SERVICE LETTER

No. 718

Subject: Bendix Magneto Bulletin No. 566 -- reference attached Avco Lycoming Service Bulletin No. 373, dated March 22, 1974.

SUBJECT: S-1200 Distributor Block and Gear Change

Figure 1.

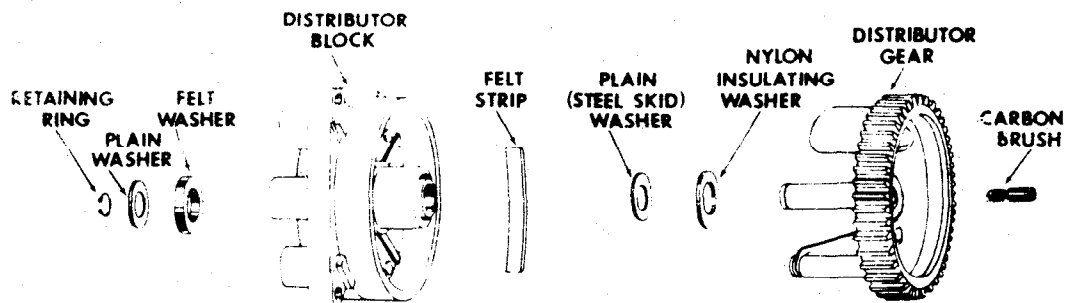
Detailed Instructions:
 It has been found that the addition of a nylon insulating washer and steel skid washer between the distributor gear electrode and the block bushing, as shown in figure 1, reduces the possibility of deterioration of the lubricant and possible seizure of the parts.

The addition of the washers make it necessary to shorten the gear end of the bushing and block. New production blocks incorporating the change are identified by a raised

Assemble large distributor gear, nylon and steel washers to new or reworked block as follows using figure 1 as a guide.

1. Saturate a new felt washer with Bendix Distributor Block Lubricant. ** Blot excess oil from washer until flat surfaces take on a "frosted" appearance, and seat washer in recess of block

2. Slide nylon insulating washer 10-391309 and plain washer 10-391511 onto gear shaft.

3. Lubricate inside of bronze bushing with a light film of Bendix Distributor Block Lubricant. ** Insert shaft of gear through distributor block and position plain washer on shaft. Using the 11 3071 Retaining Ring Pliers, install retaining ring on shaft. Rotate gear to insure there is no interference between gear electrode and block electrodes.

Once modified, the distributor block can be used only with a gear having the nylon and steel washer installed over the shaft as shown in figure 1.

Figure 2

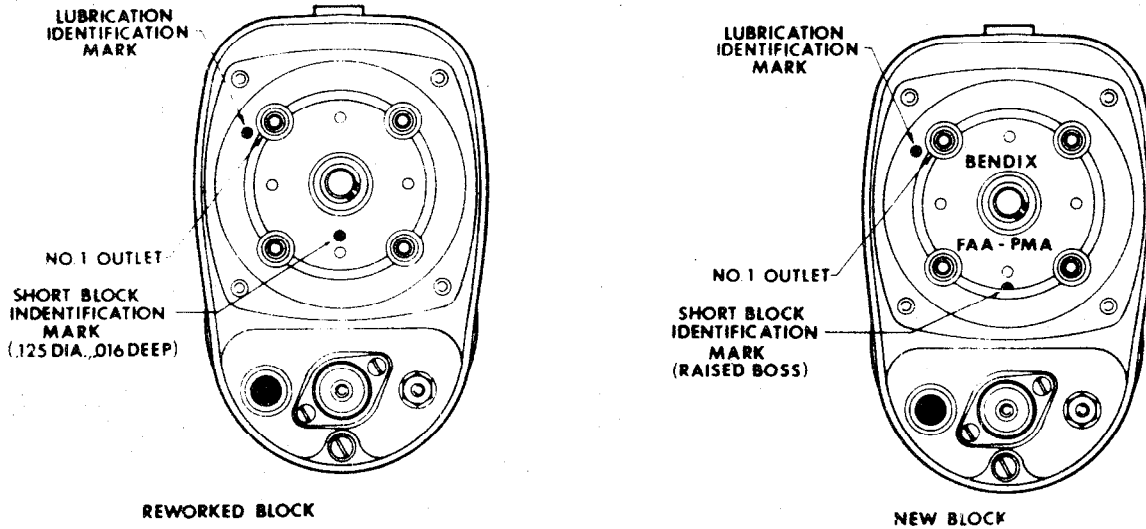
boss between the high tension towers at the six o'clock position and molded in letters as shown in figure 2. Reworked blocks are identified by a drill point indentation in the same location. New and reworked blocks both have different part numbers from the current (old) block. See Table 1.

7. Identify reworked blocks by drilling a flat bottomed hole .125" diameter and .016" deep in the six o'clock position as shown in figure 2.

a. If distributor block is not marked with a raised boss or drill point indentation to the left and adjacent to the No. 1 high tension tower (see figure 2), remove old lubricant from bushing as follows:

(3) Identify distributor block by drilling flat bottomed indentation 0.125 inch diameter and 0.016 inch deep located as shown in figure 2.

Figure 3.

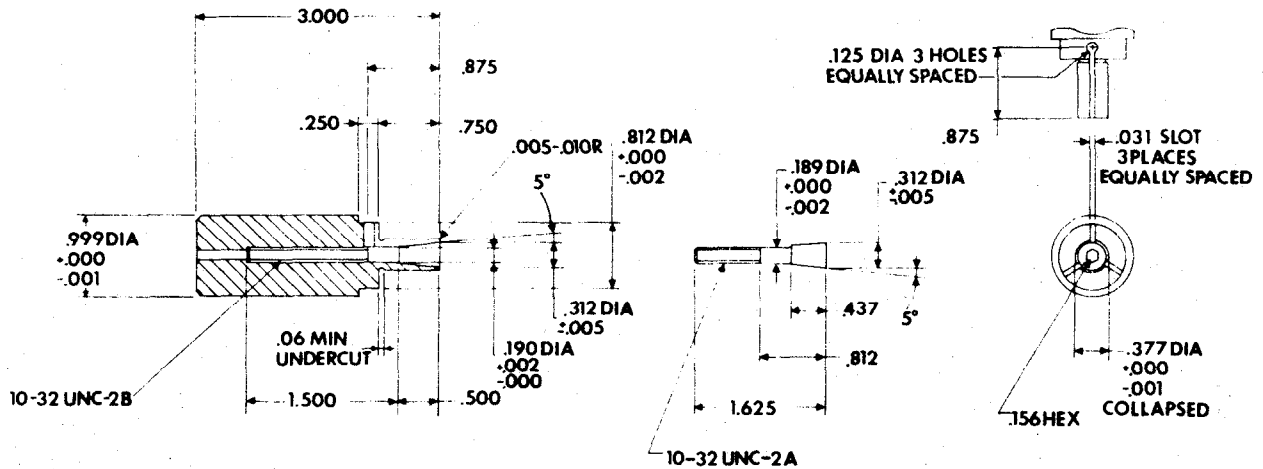
2. Fabricate an expanding arbor lathe fixture as shown in figure 3. (Similar arbors may be purchased from industry machine tool supply houses.)

3. With arbor in lathe, slide distributor block over arbor, high tension outlet tower side first, until block bushing bottoms on arbor shoulder. Tighten arbor expansion screw until block is held securely for turning operation.

Figure 4.

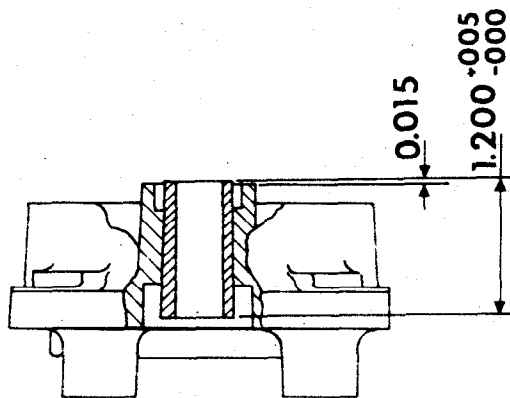
4. Use a suitable cutting tool and turn so that overall length of bushing is $1.200 + .005 - .000$ inch as shown in figure 4. (A Carbaloy tipped tool is recommended.)

5. Using same cutting tool, turn dielectric material of block so that resulting surface is .015 inch below end

of reworked bushing. See figure 4.
